Access Compliance Report

Public Rights-of-Way

(Curb Ramps)

Intersection ID: 10041631	Main Street: WHITEHALL_PARK_DR	Cross Street: N/A	Location: SW
ADA ID: E9DB8638543A	Ramp Type: PerpDiag	Initial Pass/Fail: Fail	Overall Compliance: No
Severity Score: 21.25			
Codes/Mitigation Info/Possible Solution		Field Measurements/Component Compliance

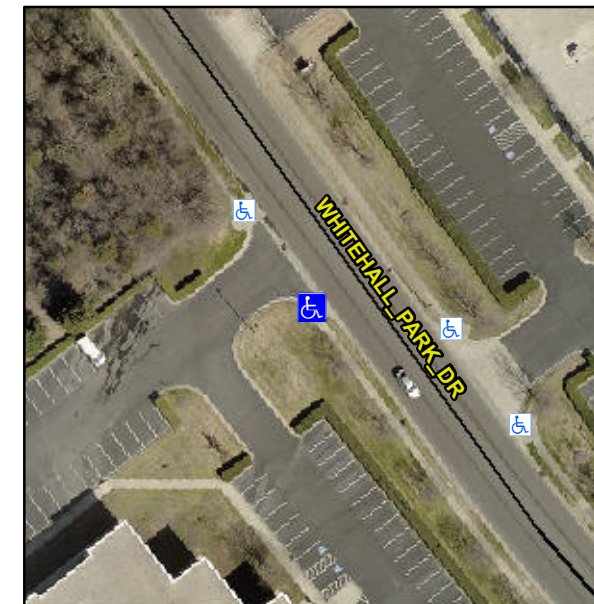
R304.5.1, R304.2.2

Compliance	Description	Data	Compliance	Description	Data
N/A	Ramp Length (in)	47.0	No	Ramp Slope (%)	10.8
No	Ramp Width (in)	41.5	Yes	Ramp XSlope (%)	0.6
N/A	Flare Type LT	N/A	N/A	Flare Type RT	N/A
N/A	Flare Slope LT (%)	N/A	N/A	Flare Slope RT (%)	N/A
N/A	Flare Traversable LT?	N/A	N/A	Flare Traversable RT?	N/A
N/A	Landing Length (in)	N/A	N/A	DWS Provided?	N/A
N/A	Landing Width (in)	N/A	N/A	DWS Contrast?	N/A
N/A	Landing Slope (%)	N/A	N/A	DWS Length (in)	N/A
N/A	Landing X Slope (%)	N/A	N/A	DWS Full Width?	N/A
N/A	Landing Curb? (Y/N)	N/A	N/A	DWS Offset (in)	N/A
N/A	Shared Landing?	N/A			
N/A	Gutter Ponding?	N/A	N/A	Gutter Slope (%)	N/A
N/A	Gutter Lip Ht (in)	N/A	N/A	Gutter X Slope (%)	N/A
N/A	Painted X Walk1?	No	N/A	Painted X Walk2?	No
	X Walk 1 Direction	To NE		X Walk 2 Direction	To NW
N/A	X Walk 1 Width (in)	N/A	N/A	X Walk 2 Width (in)	N/A
	X Walk 1 Slope (%)	2.4		X Walk 2 Slope (%)	1.6
	X Walk 1 X Slope (%)	0.5		X Walk 2 X Slope (%)	2.9

Remove & Replace Curb Ramp With Two New Directional Ramps or Equivalent.
